**STAFF RECOMMENDATION**  
**3964 Woodlawn Drive**  
**July 18, 2018**

**Application:** New Construction—Infill and Outbuilding  
**District:** Woodlawn West Neighborhood Conservation Zoning Overlay  
**Council District:** 24  
**Map and Parcel Number:** 11604029800  
**Applicant:** Chris Goldbeck, P. Shea Designs  
**Project Lead:** Melissa Baldock, melissa.baldock@nashville.gov

**Description of Project:** Application is construct infill and an outbuilding on vacant lot.

Figure 3. This site plan shows the existing sewer easement in yellow and the proposed relocation of the sewer easement in red.

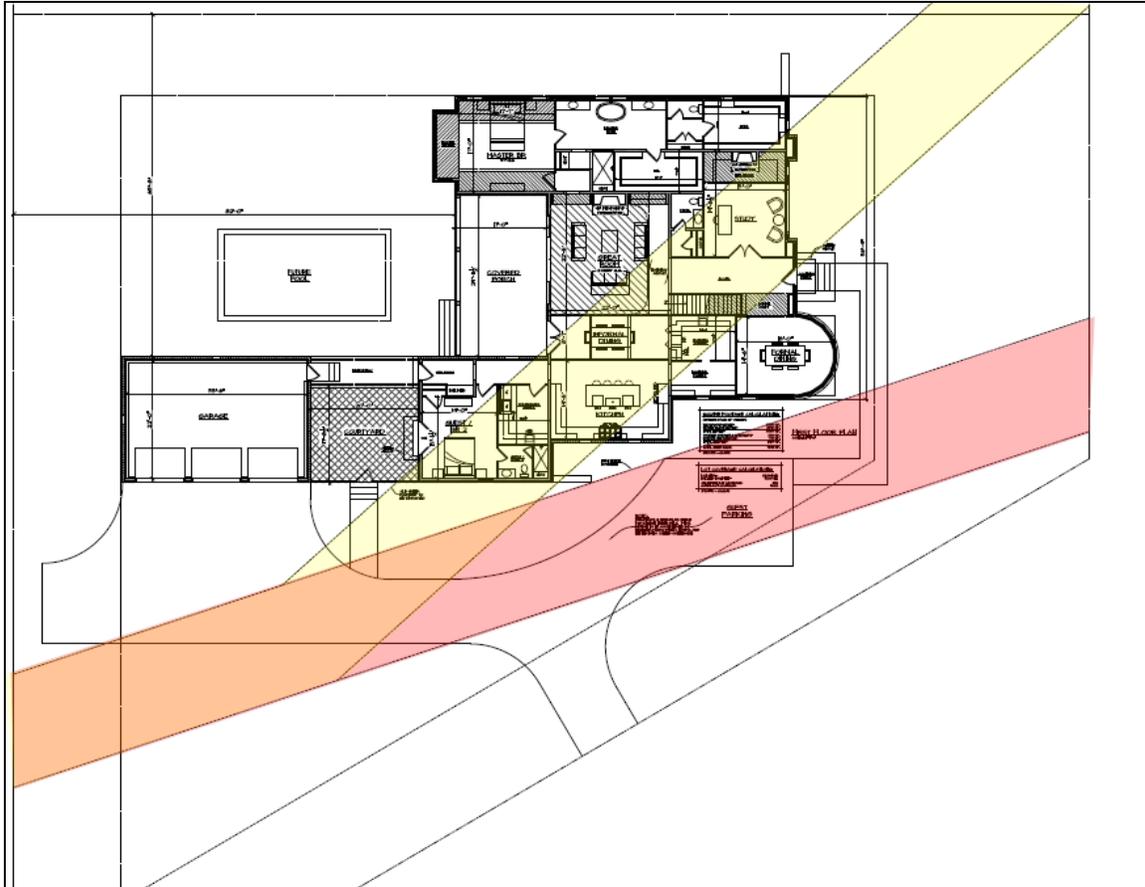
Ensworth Avenue bisects the lot, creating a triangular piece that is still part of the lot 3964 Woodlawn. This street condition was created in 1929-1930. The lot currently has a sewer easement that runs through it, making it difficult to build on. The applicant plans to relocate the sewer to allow for adequate space for the construction of infill (Figure 3).

Figure 4. Staff's suggestion for relocating the guest parking.

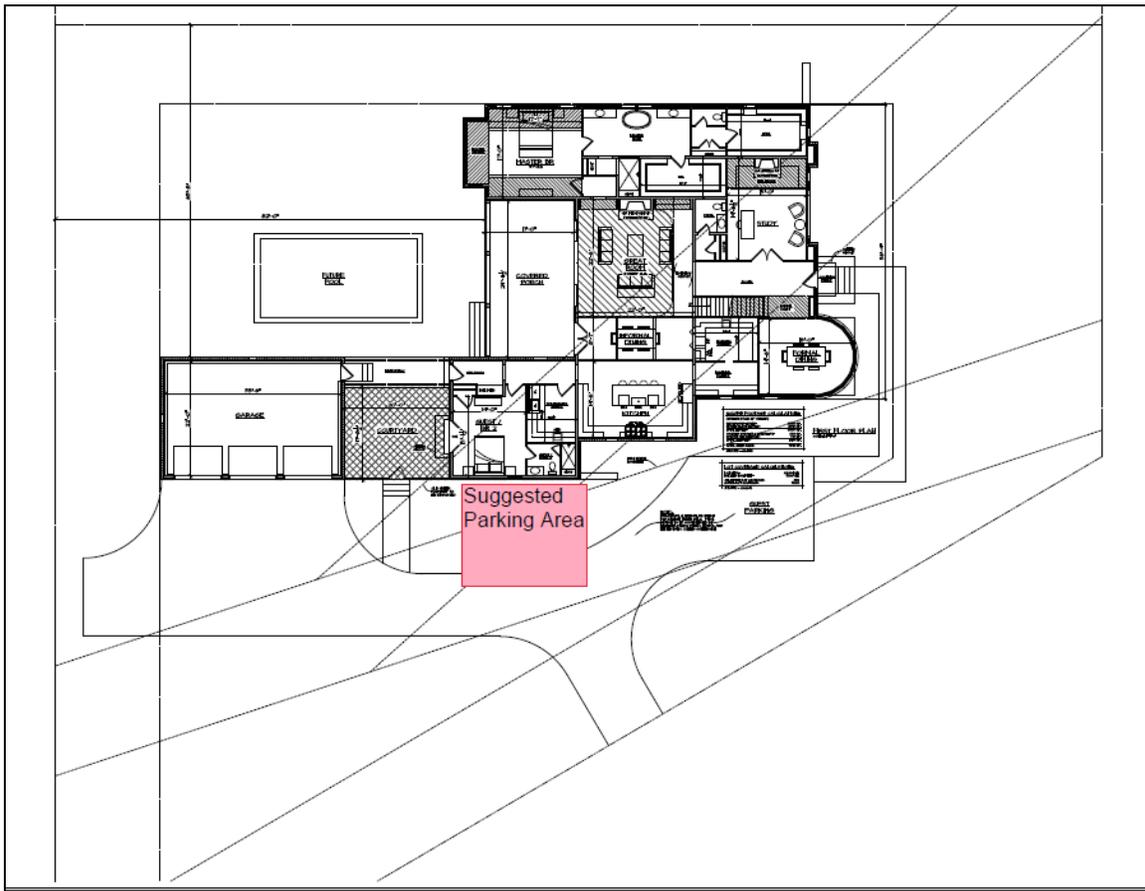
Vehicular access to the site will be via new curb cut off of Ensworth Avenue. Staff finds this to be appropriate because the site lacks an alley. The site plan shows guest parking towards the front of the house, and staff finds this location to not be appropriate. There is no street parking permitted on Woodlawn, Ensworth, and Montgomery Bell Avenues, so staff finds that additional uncovered parking for guests could be appropriate off of Ensworth Avenue. However, staff recommends that it be located towards the rear half of the lot (Figure 4). With this recommendation, staff finds that the house's orientation meets Section II.B.1.f. of the design guidelines.
